TriMet Kellogg Bridge Design Review Meeting

The DLC will be reviewing application DR-11-01 for substantial compliance with the Downtown Design Guidelines. The DLC will then make a recommendation to the Planning Commission to approve or deny the application.

Subject: **File:** DR-11-01
Applicant: TriMet
Owner(s): TriMet¹
Location: City of Milwaukie, Oregon Department of Transportation, and Union Pacific Railroad rights-of-way on Tax Maps 1S1E36BC, 1S1E36CB, and 1S1E35AD between SE Lake Rd and SE 22nd Ave
NDAs: Historic Milwaukie and Island Station

2. View from South side of Lake Road looking at jump span and North abutment - Concrete jump span with steel fascia

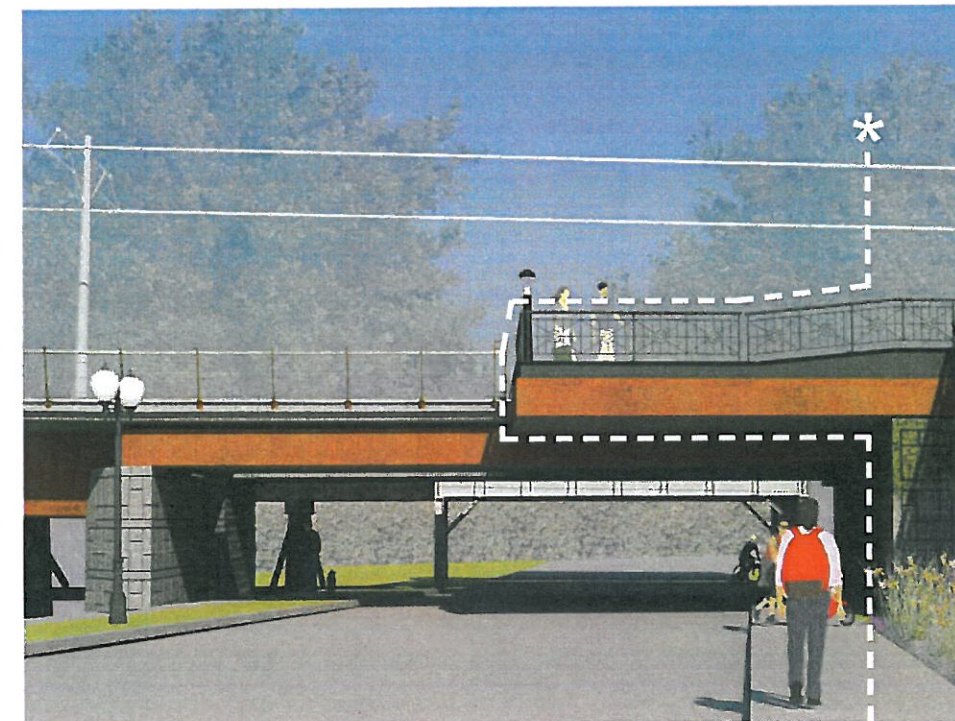
B. Should the proposed concrete jump span structure be clad in weathered steel to provide visual continuity?

The applicant proposes to clad the concrete jump span in weathered steel to visually integrate the jump span and the light rail bridge structures. Unfortunately, it is more difficult to remove graffiti from weathered steel than from concrete. Given the proximity of the jump span to Lake Rd and the light rail station, it is possible that the jump span structure may be more vulnerable to graffiti than the rest of the bridge.

If the DLC recommends not cladding the jump span structure in weathered steel, staff will include a condition of approval to that effect for the Planning Commission's consideration.
